**KNOXVILLE HISTORIC ZONING COMMISSION
STAFF REPORT - CERTIFICATE OF APPROPRIATENESS APPLICATION**

PROPERTY ADDRESS: 601 W Summit Ave 37902
DISTRICT: Old City Hall H-1

FILE NO.: 10-I-15-HZ

MEETING DATE: 10/15/2015

Contemporary photo of building, showing south elevation.

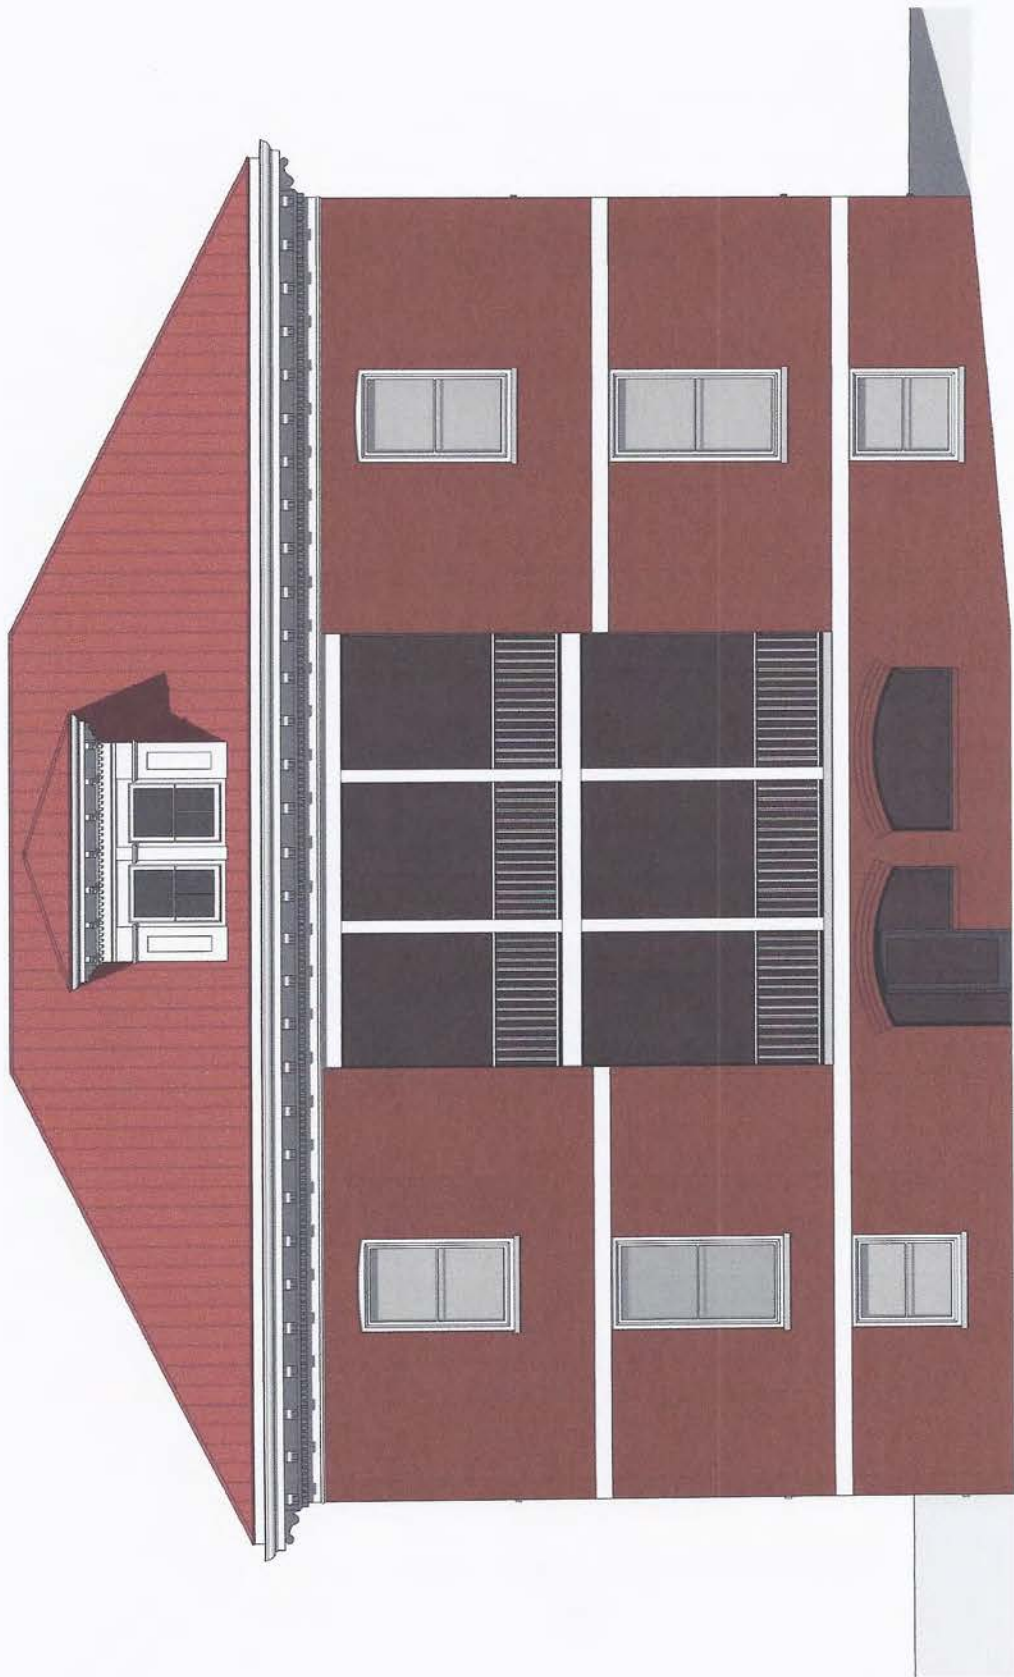
1. The south façade of the building originally had two levels of open porches or "balconies."
2. The metal firestair was installed sometime prior to 1982 and inappropriately altered the south façade, along with brick infill of windows.

3. Although the porch balconies are proposed to be infilled with glass, the removal of the firestair would be more sympathetic to the original design.
4. The glass tinted glass will screen the office use within.

Approval is recommended with the condition that confirmation is provided that possibilities for reducing the size of the parking lots have been exhausted. Additionally, the parking lot is to be landscaped with vegetation around the perimeter, especially along Broadway, and as much landscaping as possible is to be incorporated internally to the parking lot. A landscape plan will be required prior to final approval.

PROPOSED PARKING LAYOUT

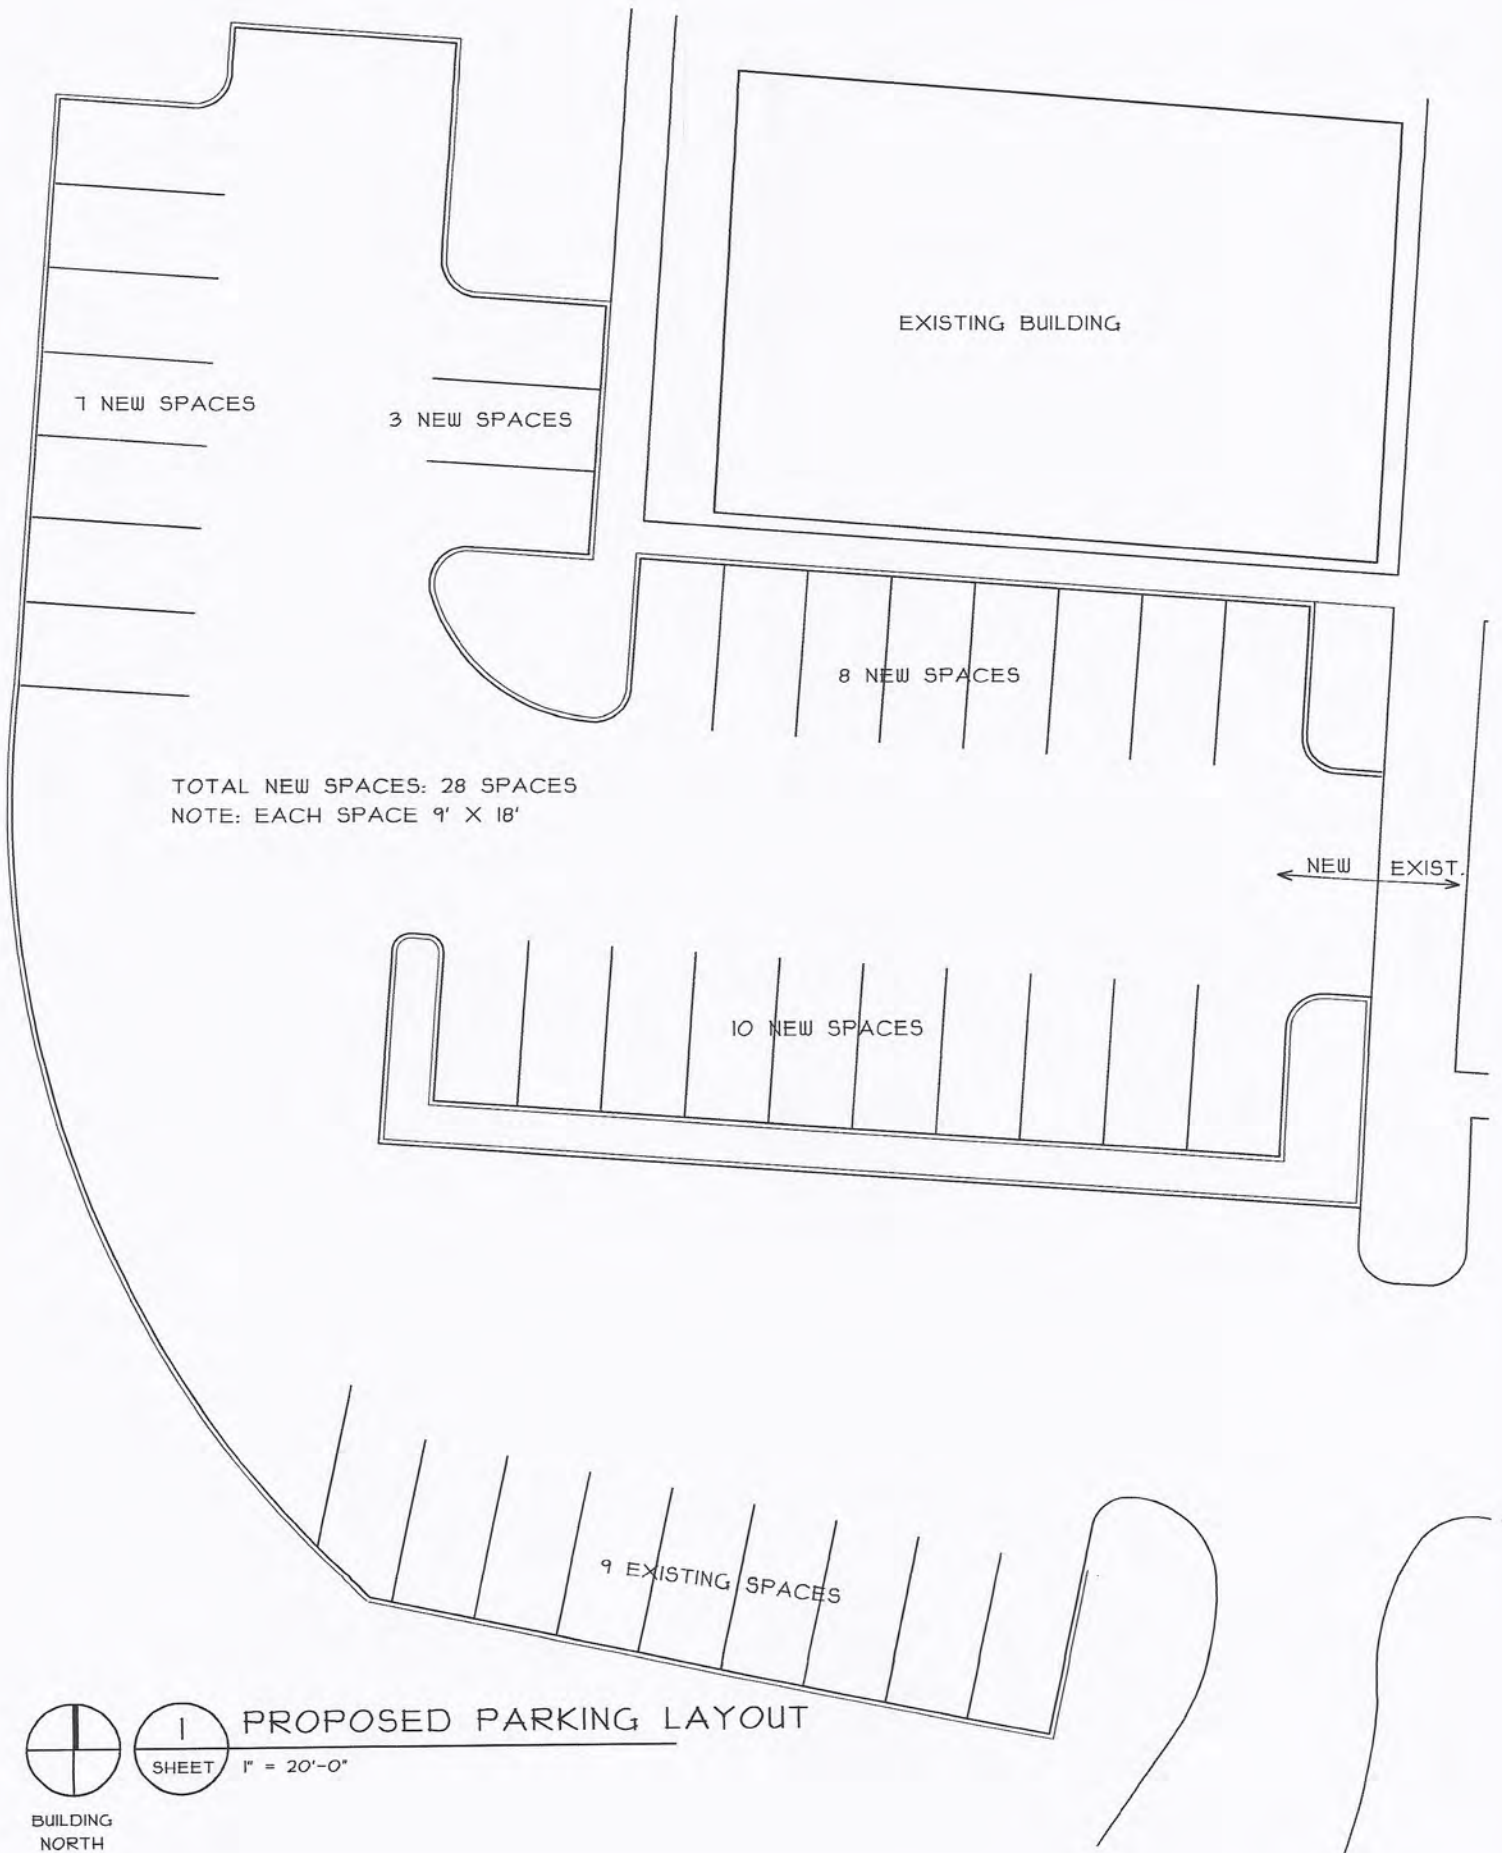
It has not yet been determined if the firestair will be required to meet the building code. If it is determined that the firestair is not required, the second-level window will remain intact. The building has a new use as office spaces, so new parking for daily users is requested given that the closest parking deck is at Locust Street and Summer Place.

Duncan Law School – West side showing proposed location of fire escape

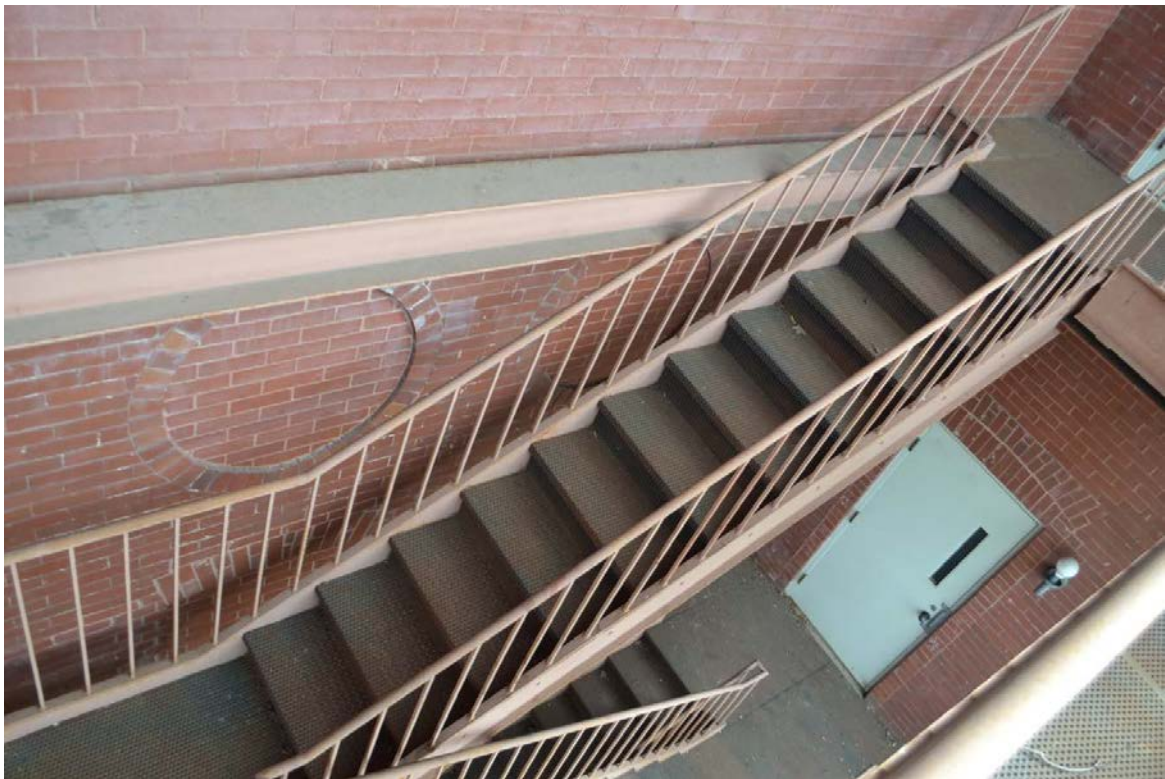
5. The new firestair on the west side will be somewhat visible from Broadway and from Western Avenue, especially since two trees had be removed.
6. An original window would be required to be replaced with a fire door (the original window opening would be enlarged). However, the firestair can be removed in the future without destroying substantial additional historic fabric. The exit door would be designed to match the existing panelled front entry door on the north side of the building.

7. The proposed new firestair will have structural support of brick to match the existing brick on the building
8. The firestair could be located on the east side of the building; however, it would intrude upon an important feature of the campus, which is a grassed green space with heavy tree cover.
